***RE: Comments on EPA DEIR/LRC Responsiveness Summary***

**Review by the General Electric  
Company of the USEPA Responsiveness  
Summaries: DEIR and LRCR**

**December 2000**

Figure 6-2. Comparison of calculated mass for 1984 and 1994 samples within USEPA clusters used for area-based mass calculations in the LRCR Responsiveness Summary.

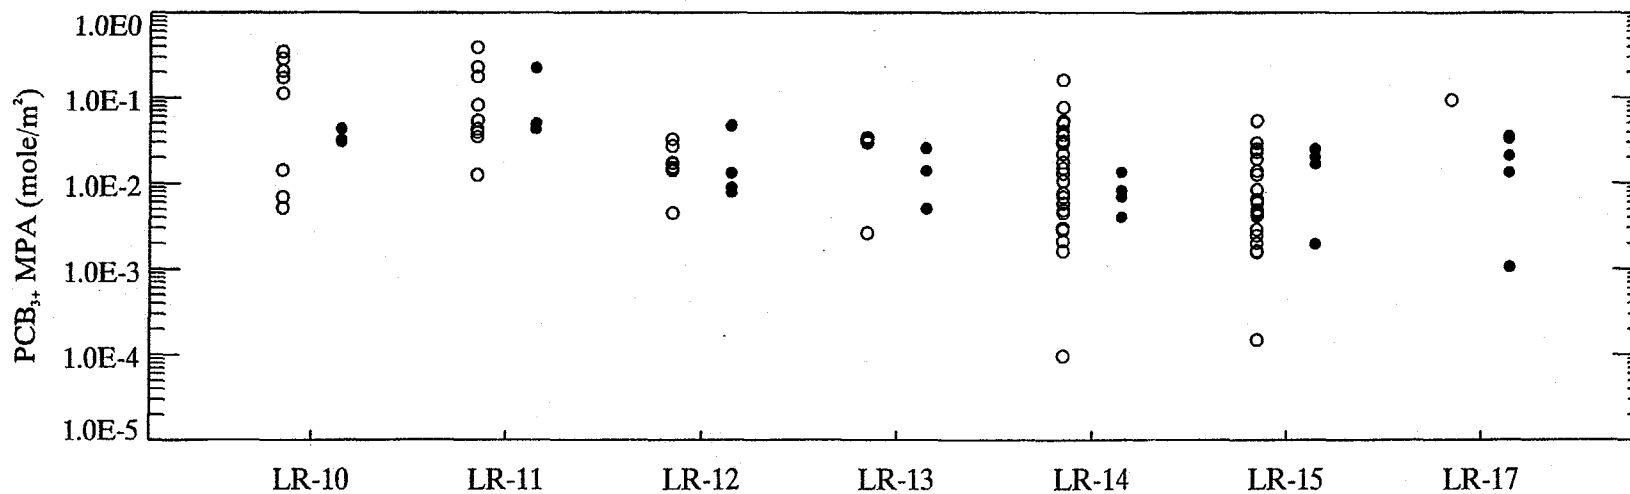
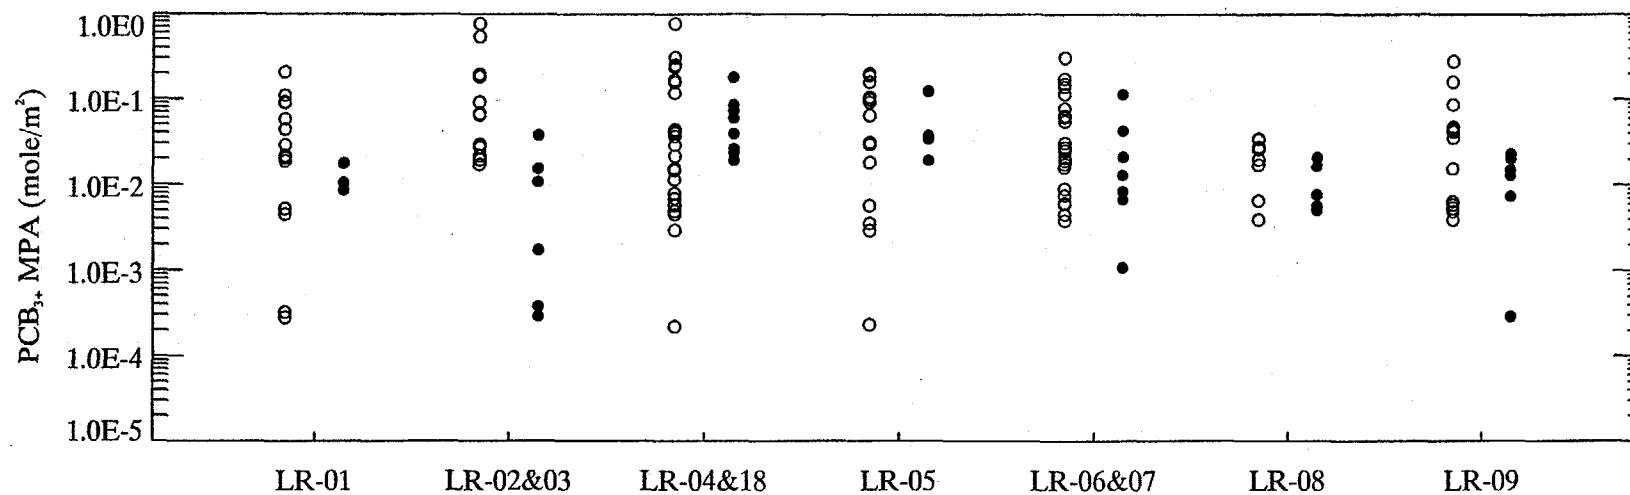
Another significant error in the USEPA analysis is the failure to consider the uncertainty associated with the average PCB MPA calculated for each “cluster.” USEPA calculated its uncertainty estimate for the overall mass loss using the distribution of the mean MPA ratios among all the different “clusters” used in the calculation. However, the estimate did not account for the uncertainty associated with the average 1984 and 1994 mass within each individual “cluster.” As shown by Figure 6-2, excluding the variability of 1984 and 1994 mass within the “clusters” is a significant oversight. Figure 6-2 demonstrates that the individual mass estimates
